Mine Name	Mine ID	Operator	Activity Type	Region	Activity Date
Grosvenor Coal Mine	M102976	Anglo Coal (Grosvenor Management) Pty Ltd	Inspection	Central	05/07/2016

## Mine Record Entry

### 1.0 Roof Fall HPI Report 101 LW- 2422m chainage

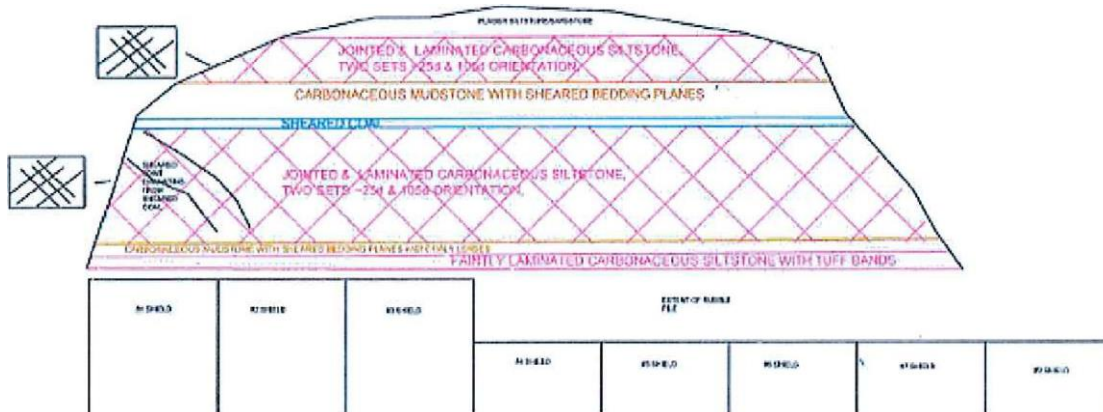
Wayne Bull (UMM) reports cavity at chocks #3 and #4 beginning “to lip on” and bagging of mesh just out-by the face line at the maingate. Assume “lip on” is manager speak for cavity getting bigger

Bull did not consider it significant. On what basis, he has worked both at North Goonyella and Moranbah North, he should know better. Same seam, same problems with gas and roof.

No indication of what time Wayne Bull was at the face the previous day, how much cutting took place or a timeline of what occurred and what the cavity and bagging progressed since Bull was there.

Later, on the sixth shear for the day, as the shearer entered and pulled up the face from the MG a fall occurred —a photograph of a view into the cavity and a cross section of the strata are shown above.

### 7 Dot Points

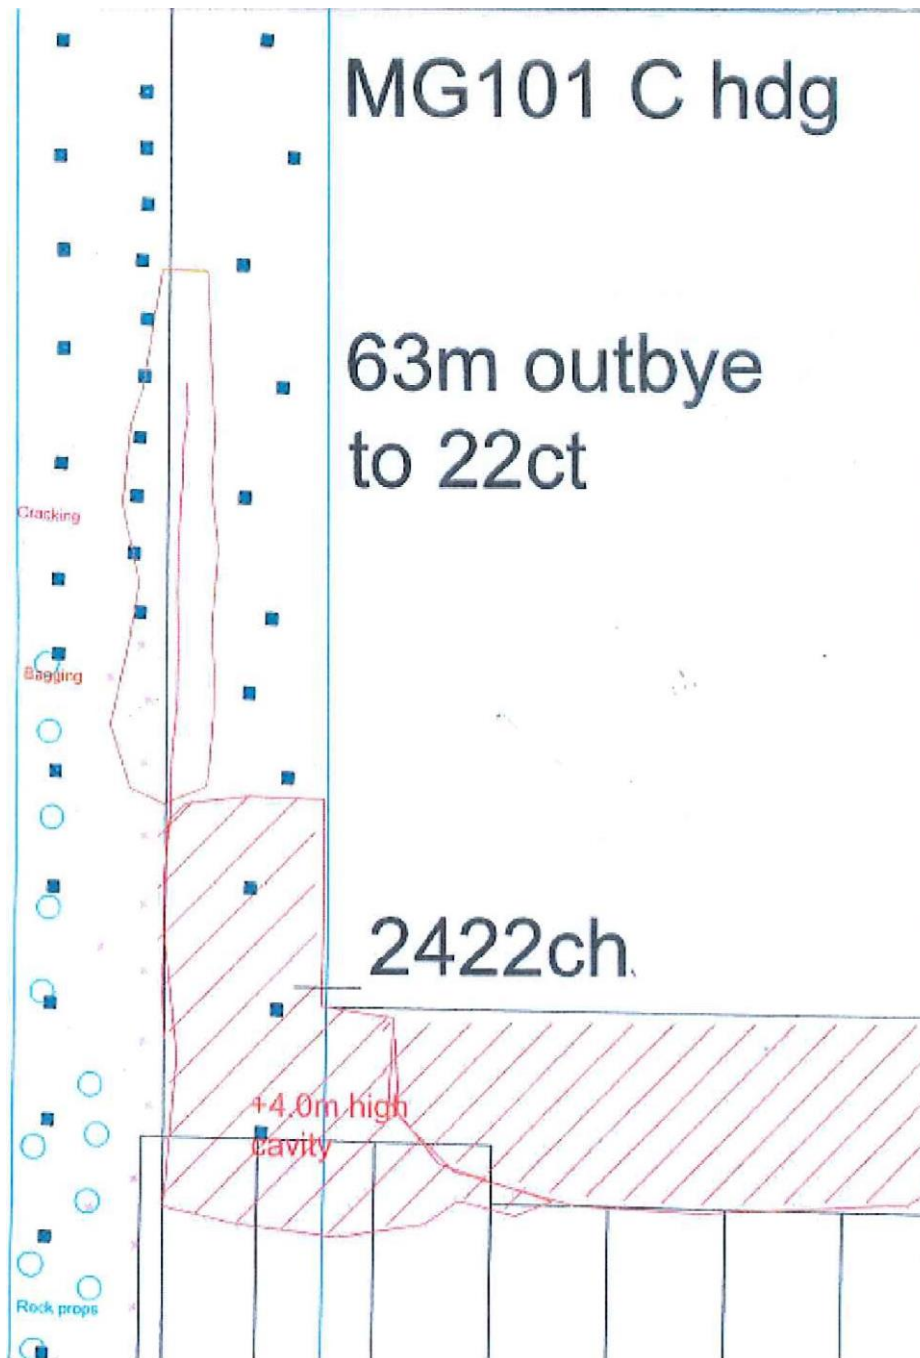
1. Change management failure on seam changes for cutting profile
2. Goonyella Middle seam norm
3. Goonyella Middle seam norm
4. Goonyella Middle seam norm
5. Norm except for row of at least 1 extra 8.2 megabолt in the centre of the roadway, often 2 megabолts
6. Floor heave and floor cracking. Any methane liberated?

7. Of course there should be full analysis.

Nothing about what is to take place before mining restarts except face recovery. Last paragraph is a Goonyella Middle seam norm for support. Whether pre belt move well after the roadway is already driven or as part of the normal mining cycle is the question.
